MEMORANDUM

TO: HONORABLE MAYOR AND MEMBERS OF THE CITY COUNCIL
FROM: DIRECTOR OF PLANNING, BUILDING AND CODE ENFORCEMENT
DATE: DECEMBER 5, 2006
SUBJECT: LONG POINT (TERRANEA) RESORT HOTEL
PROJECT: ZON2006-00615 (REVISION 'E' TO CUP 215, ET. AL.)

Adopt Resolution No 2006-_____, approving Revision 'E' to Conditional Use Permit No 215 et al, to allow an updated and revised site plan, grading plan and public amenities plan for the Long Point Resort Hotel and approving new and modified Conditions of Approval associated with the updated project plans.

Attachment: "Coastal Setback Exhibit T.P.M. 26073" (copied as 3 overlapping pages)

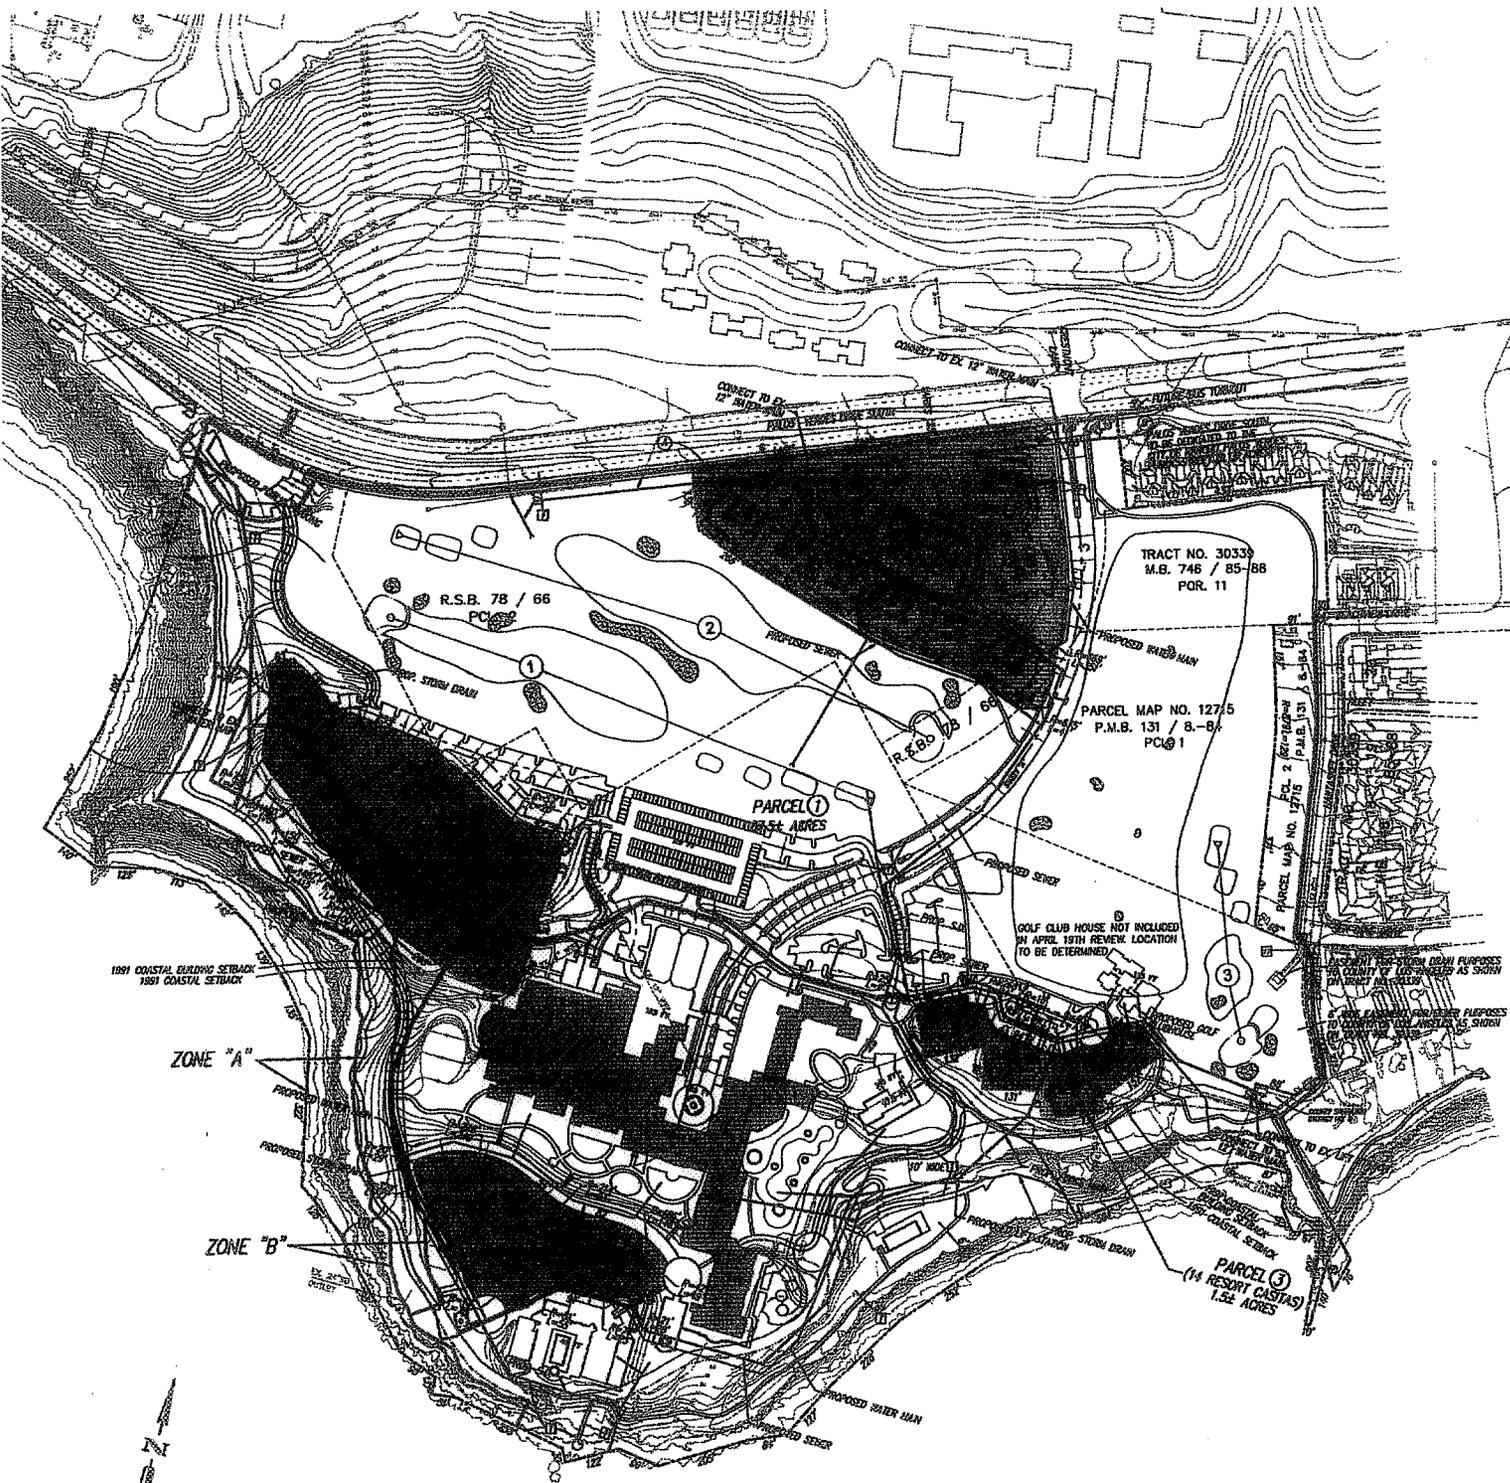
It should be noted that in their August 18, 2006 review of the first version of the Landscape Plan, the City Biologist, David Magney Environmental Consulting objected to the lack of delineation of the Plant Zones in that version of the Plan, and in particular stated that, "... Condition 78 involves Plant Zones B and B1 and they are not delineated on Sheets 1.01, 1.09, 1.10, and 1.22. Zone B on Sheet 1.20 is recognizable but it is not clearly labeled as such."
